## Duquesne Light

SUBJECT: Beaver Valley Power Station - Unit No. 2  
Docket No. 50-412  
NRC Structural Design Audit

## NRC STRUCTURAL AUDIT ACTION ITEMS

Figure 13.1  
DIFFERENTIAL PRESSURE VS. TIME  
STEAM GENERATOR CUBICLE, LOOP 1  
SERVER VALLEY POWER STATION UNIT 2

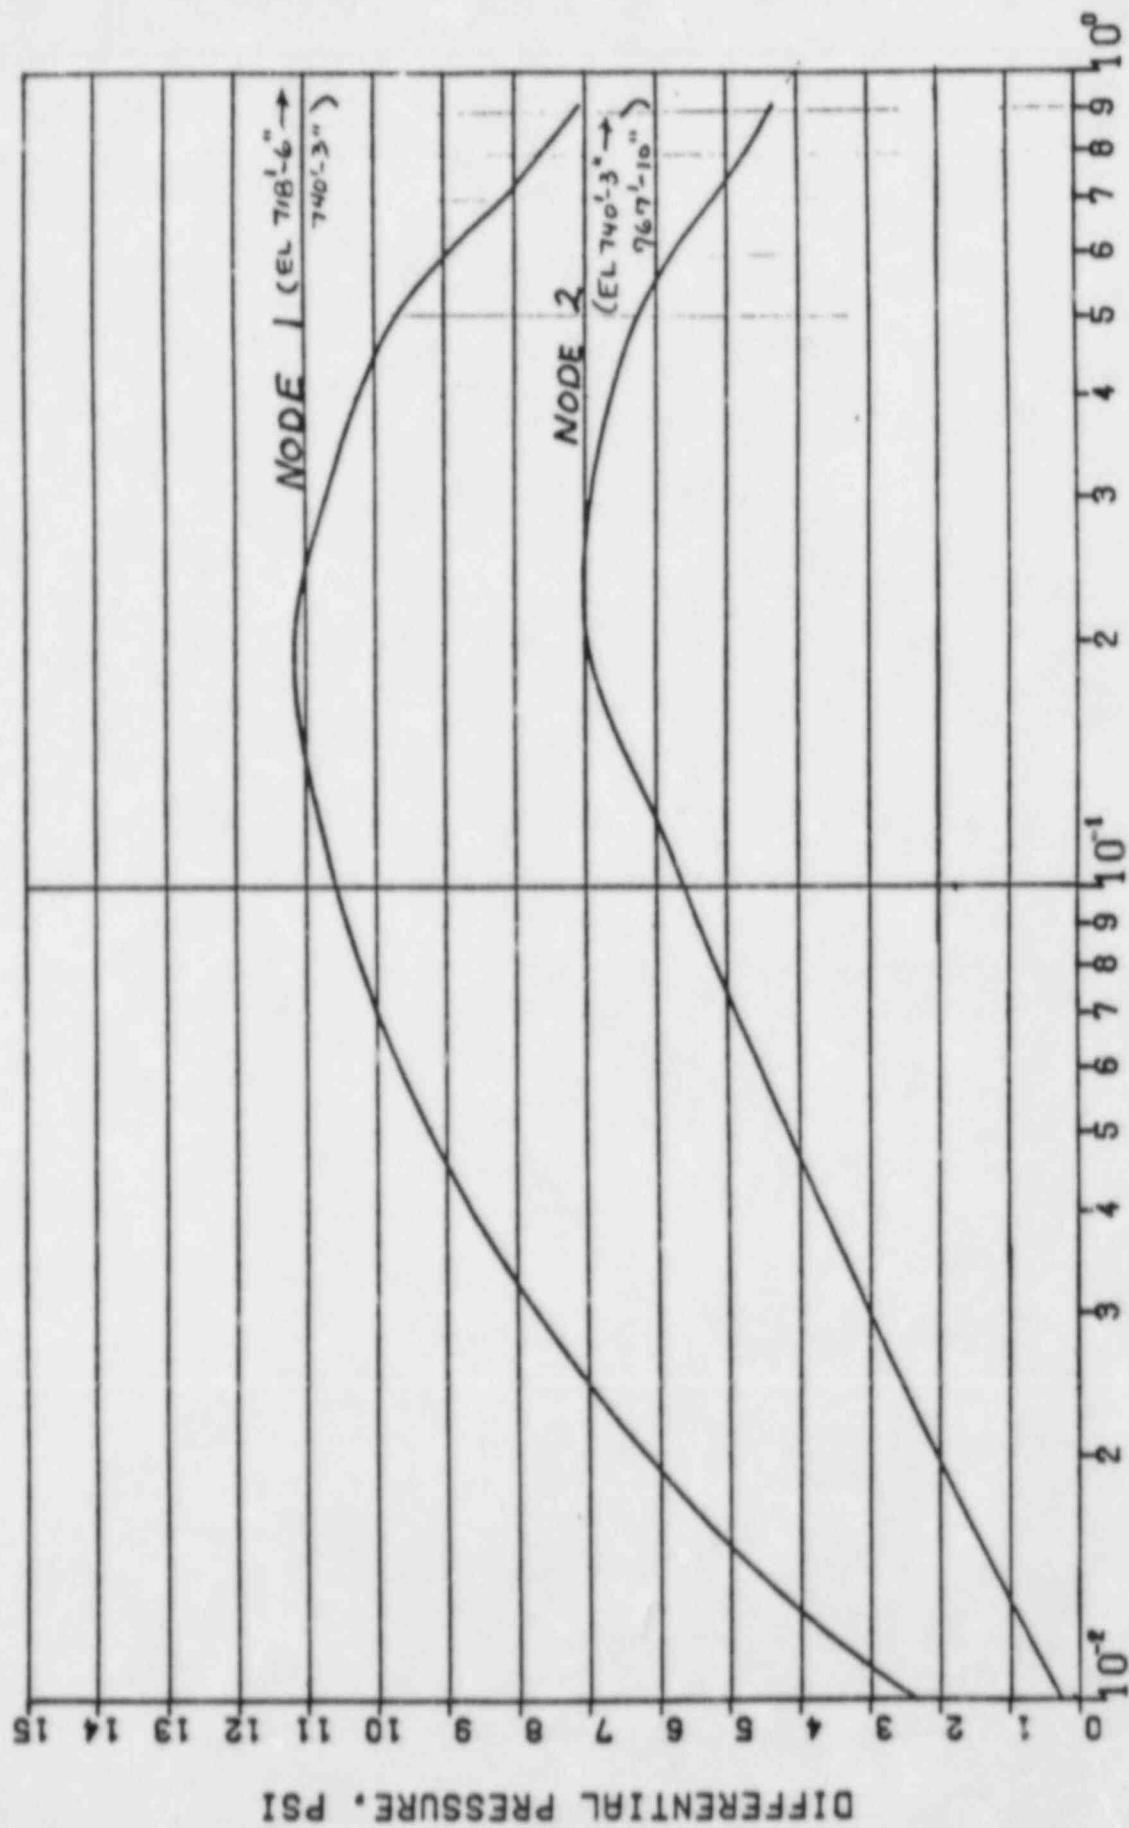
13. Provide technical justification for using a dynamic amplification factor of one for the analysis of pressurization effect on steam generator cubicles. Also, address the basis for not accounting for the cracking effect of the concrete elements during pressurization.

An elastic dynamic analysis has been performed for the steam generator cubicles when subjected to the time history of pressurization load (Figure 13.1).

The fundamental frequencies of the floor slabs, cranewall, and radial walls of the cubicles have been calculated for both the uncracked and cracked concrete conditions. For the governing structural element (a radial wall) the uncracked and cracked frequencies are 37 Hz and 27 Hz, respectively. The pressure time histories were applied to each of these structural element models and the resulting damped equations of motion were numerically integrated to determine Dynamic Load Factors (DLF). Results of these analyses justify the use of a  $DLF = 1.0$  for the pressure load  $P$  throughout the steam generator cubicle (the maximum calculated DLF was 1.04).

Figures 21.1 and 21.2  
Pressure Drop and  
Dynamic Load Factor  
Beaver Valley Power Station  
Unit 2

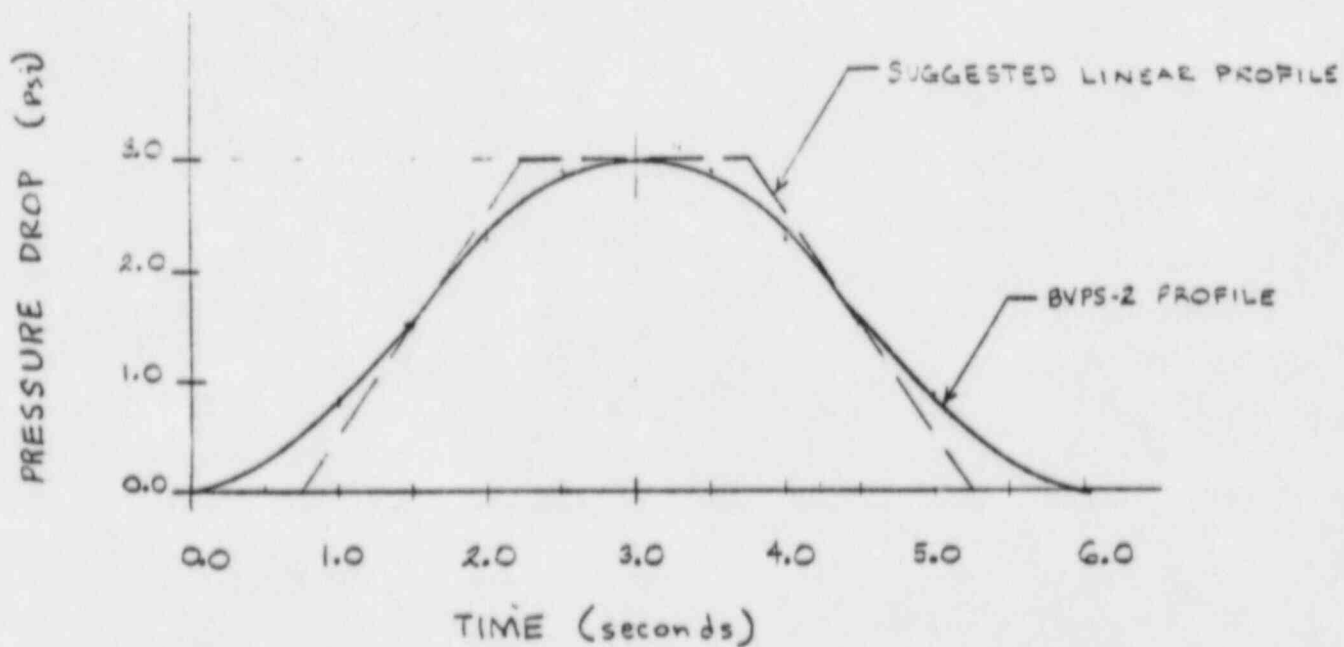
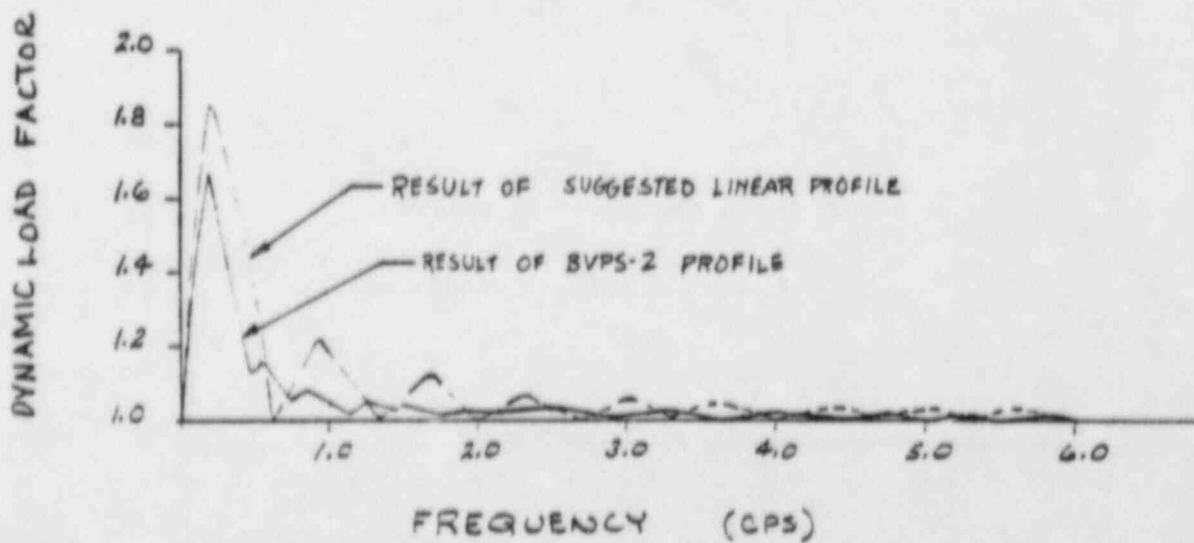
21. With respect to the issue of the rate of pressure drop for tornado definition, please provide a quantitative technical justification demonstrating that the intent of Regulatory Guide 1.76 is fully met. Also, address the adequacy of using a single degree of freedom modeling in assessing the structural response of a plate subject to the above indicated pressure drop loading.

The nonlinear pressure drop profile specified in Section 3.3.2.1 of the BVPS-2 FSAR is identical to the pressure drop profile resulting from the tornado wind model specified in WASH-1300. As stated in Regulatory Guide 1.76, the values for the design basis tornado characteristics are taken from the WASH-1300 document. Therefore, the pressure drop profile specified for BVPS-2 clearly meets the intent of Regulatory Guide 1.76.

The dynamic load factors for a series of single-degree-of-freedom systems, subjected to the pressure drop time history (Figure 21.1), were determined. The resulting DLF's were compared (Figure 21.2) to those resulting from the linear pressure drop profile (Figure 21.1) suggested in NRC Question 451.2.

It is seen from Figure 21.2 that for systems with natural frequencies greater than 4 cps the resulting DLF's are essentially the same for both pressure drop profiles.

Therefore, since the lowest natural frequency of any panel, (9 cps), is significantly above 4 cps, either profile will result in the same equivalent pressure load. Thus, it can be concluded that the intent of Regulatory Guide 1.76 has been met. The panels can be adequately modelled as single-degree-of-freedom systems based on the procedures presented in Biggs (1964) because the loading is nonfluctuating in nature and is applied uniformly over the surface of the panel.

Figure 28.2

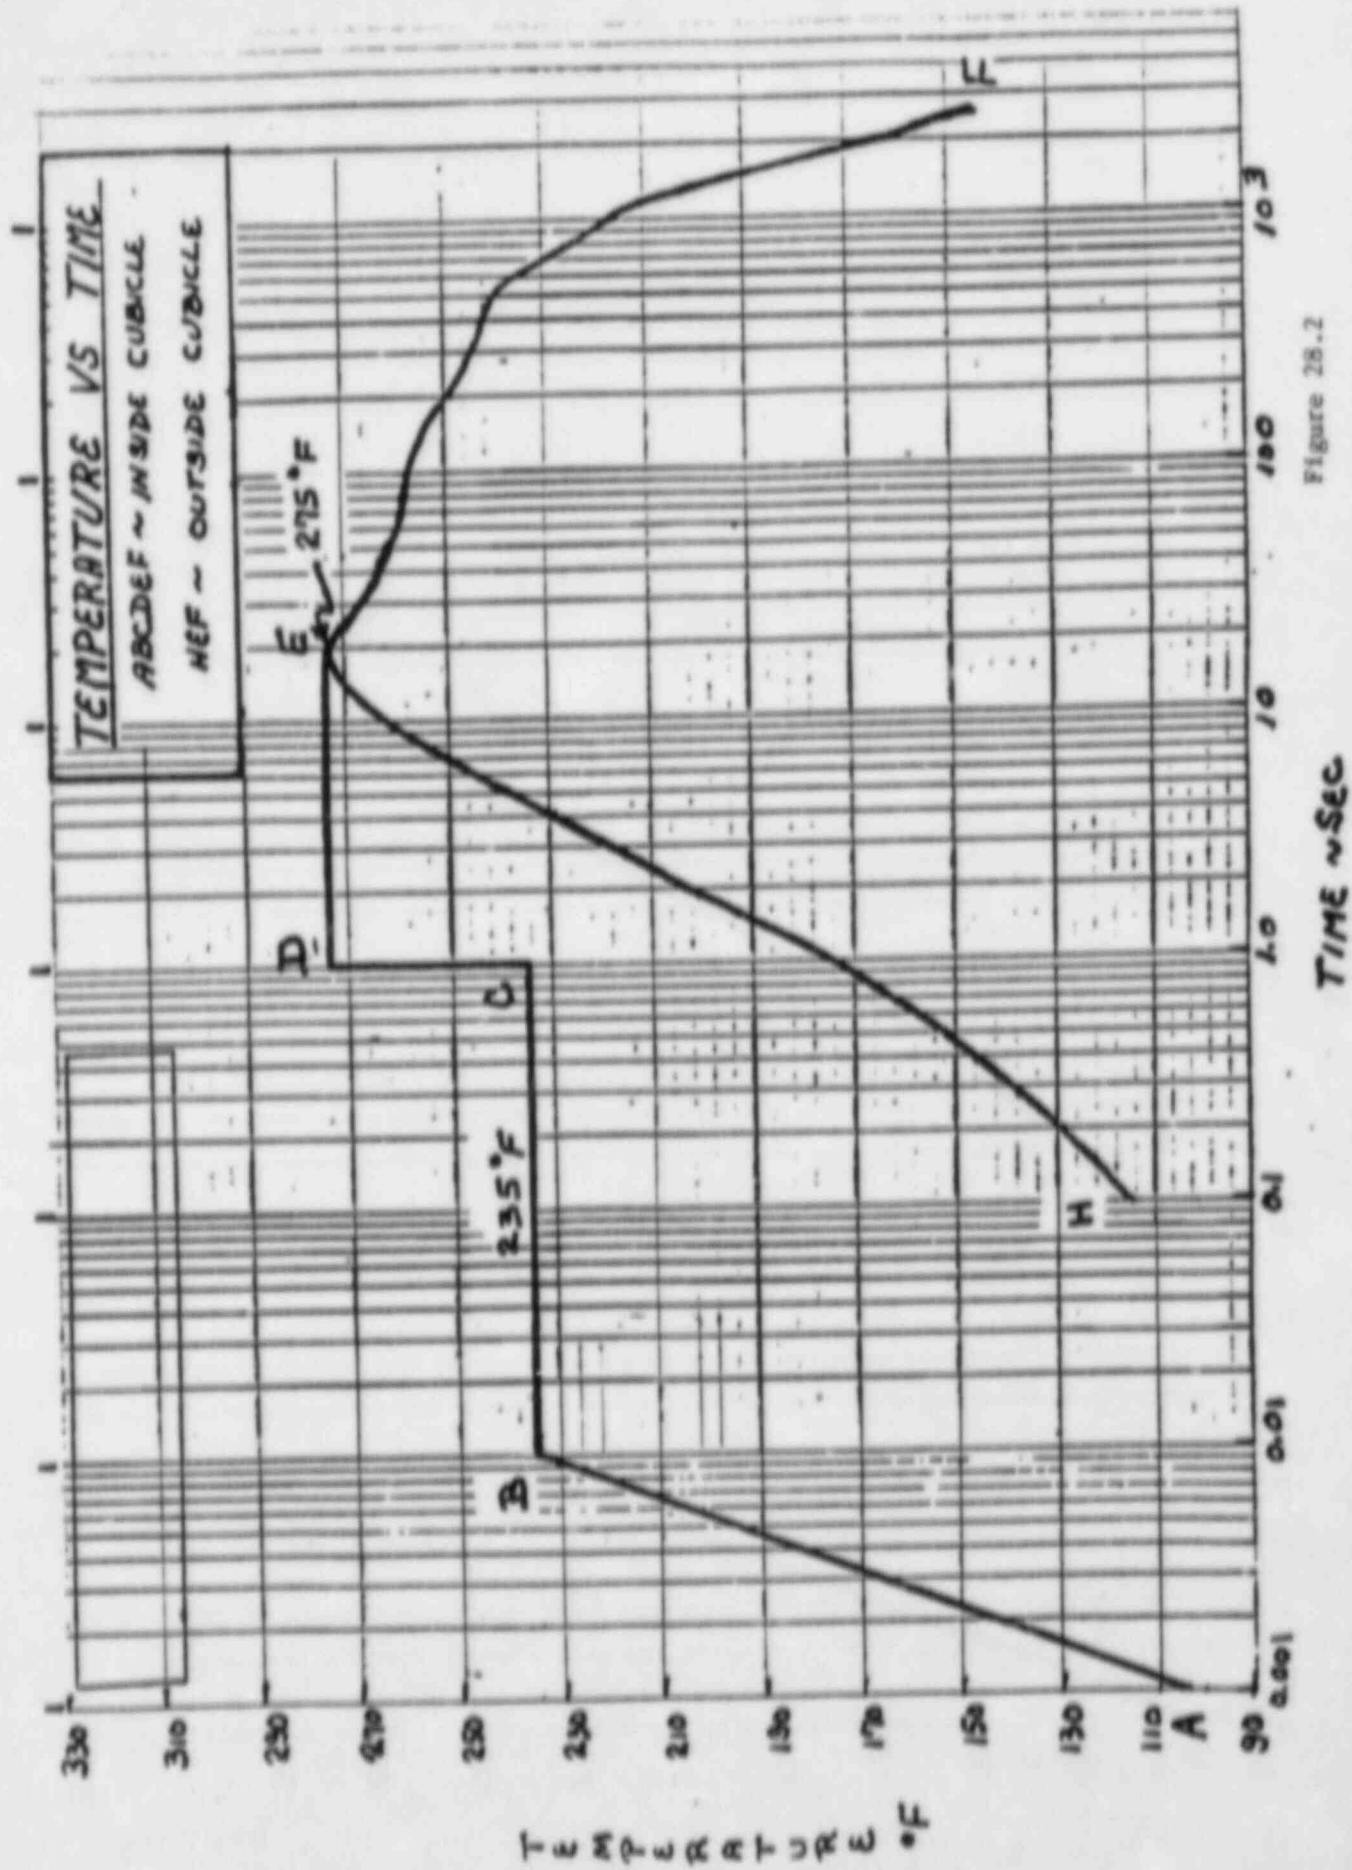
28. Please provide a simplified justification to demonstrate that  $T_a$  applicable to the cubicles in the containment need not be included in the design.

A plot of the temperature  $T_a$  for the ambient air conditions inside and immediately outside the cubicles is presented on Figure 28.2. It is noted here that within 20 seconds after initiation of the accident, the ambient air temperatures inside and outside of the cubicle are identical. This will lead to symmetric thermal stress without bending in the walls and floor slabs of the cubicles. With time and this uniform temperature throughout the containment internals, stress-free thermal growth will occur.

Figure 3.3.1.II.3-1

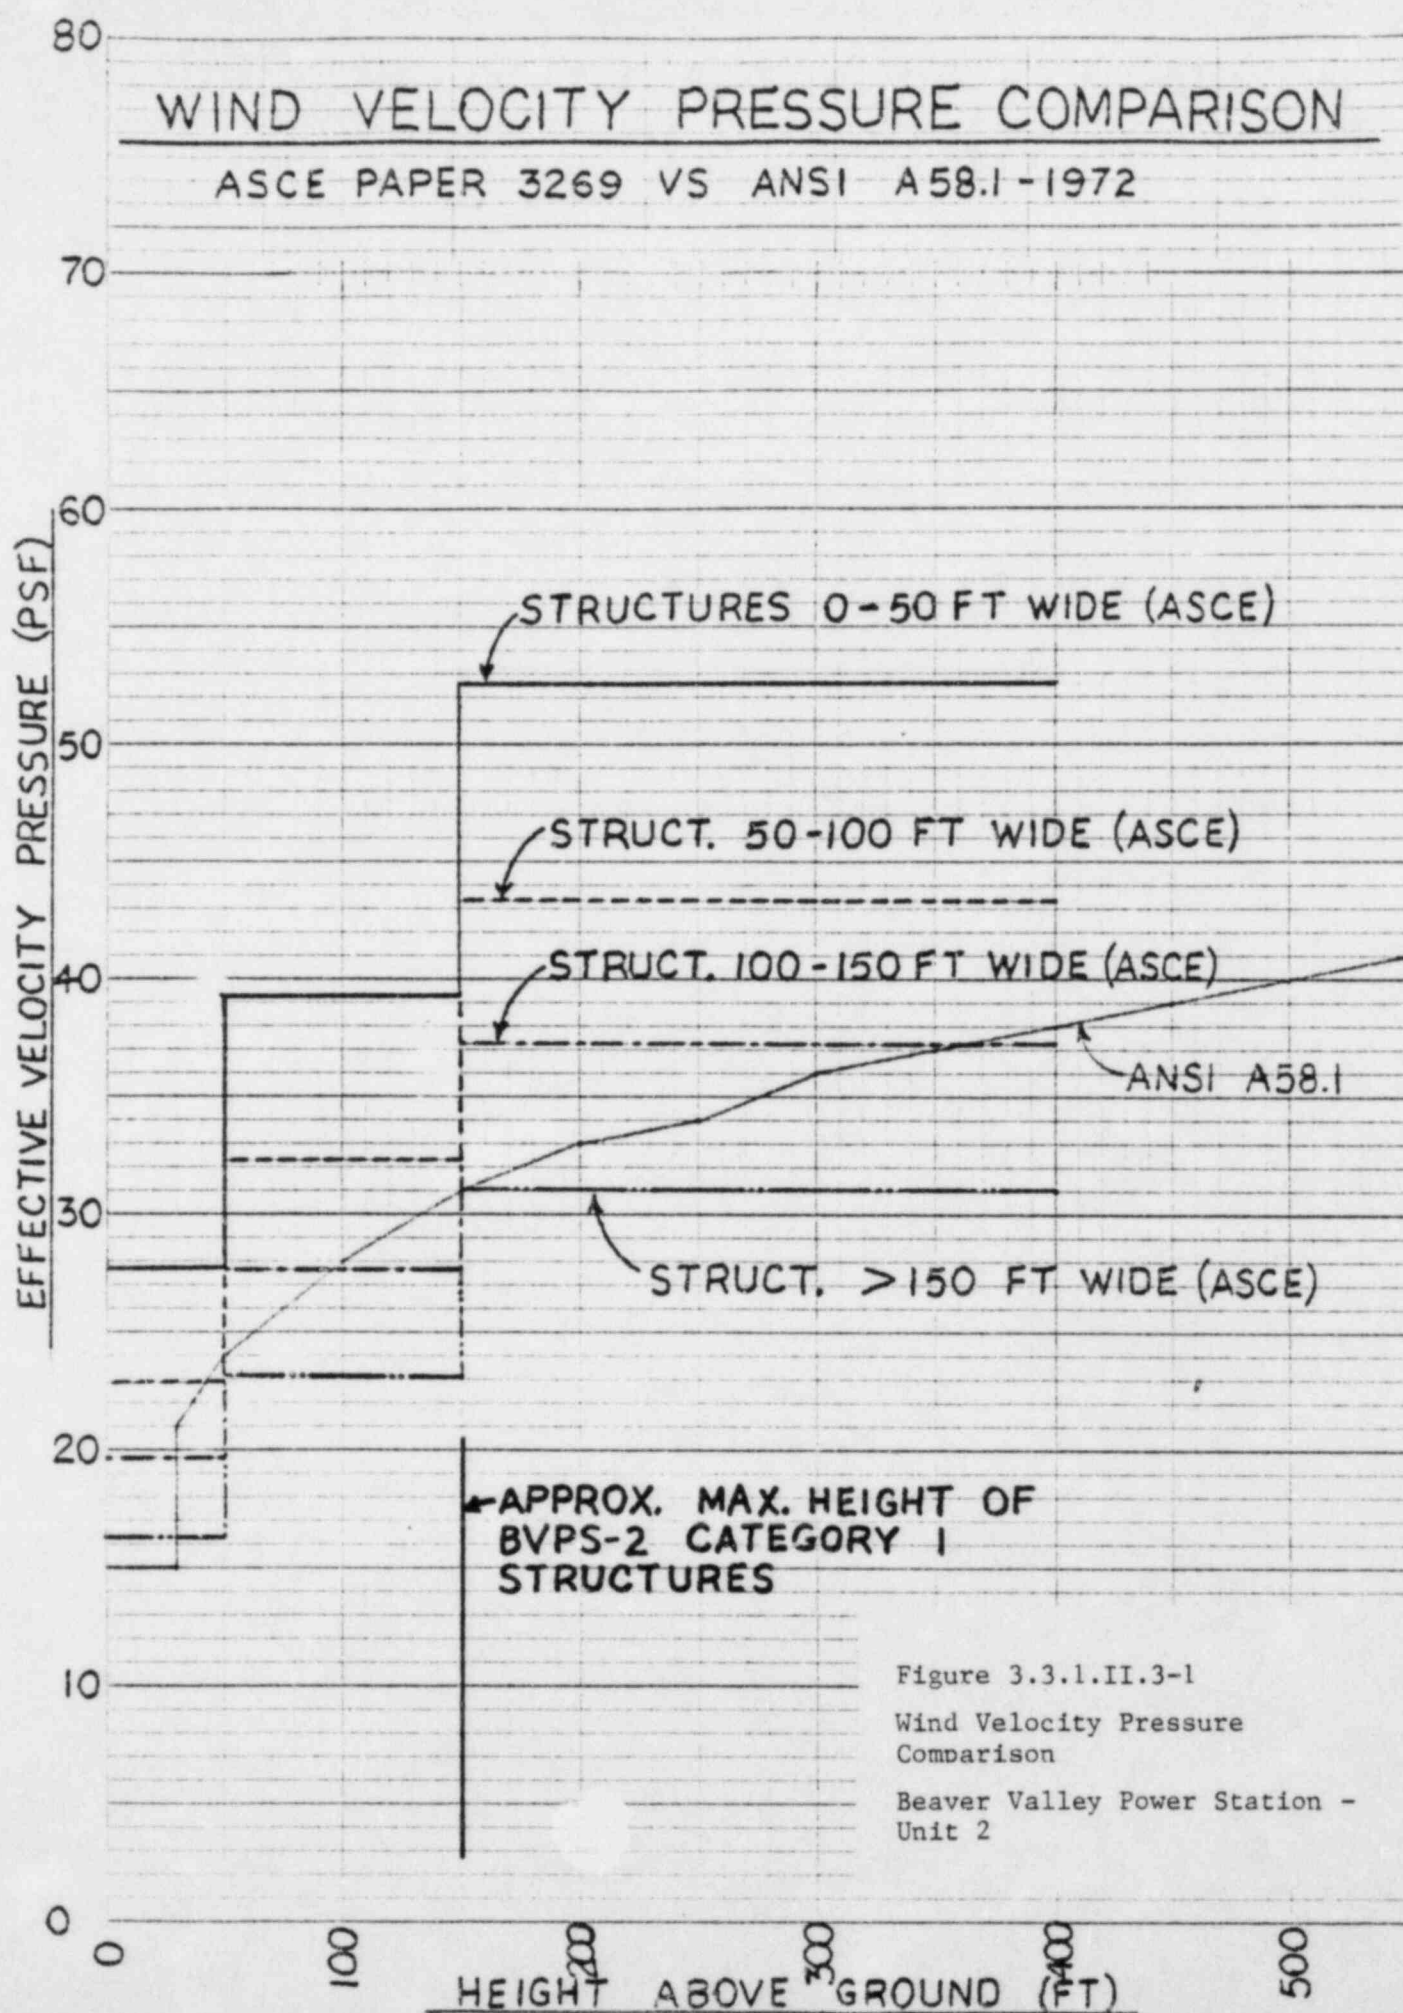
3.3.1.II.3 - With respect to the definition of wind loading, the Beaver Valley 2 plant referred to ASCE Paper No. 3269 for derivation of wind pressure on structures. The pertinent SRP Section 3.3.1 Revision 2, however, considers the ANSI A 58.1 code as the acceptable base document for defining wind loads.

For a fastest-mile wind speed 30 ft above ground of 80 mph (FSAR Section 3.3.1.1), the effective velocity pressures determined in accordance with ASCE Paper No. 3269, which are used for BVPS-2, are comparable to those required by ANSI A58.1-1972. Figure 1 shows the values from ANSI 58.1, Table 5, Exposure C as well as those used for BVPS-2.

Therefore, while there is a difference in the manner in which building response to wind gusts is considered by ANSI A58.1 and ASCE Paper No. 3269, there is no significant difference between the wind velocity
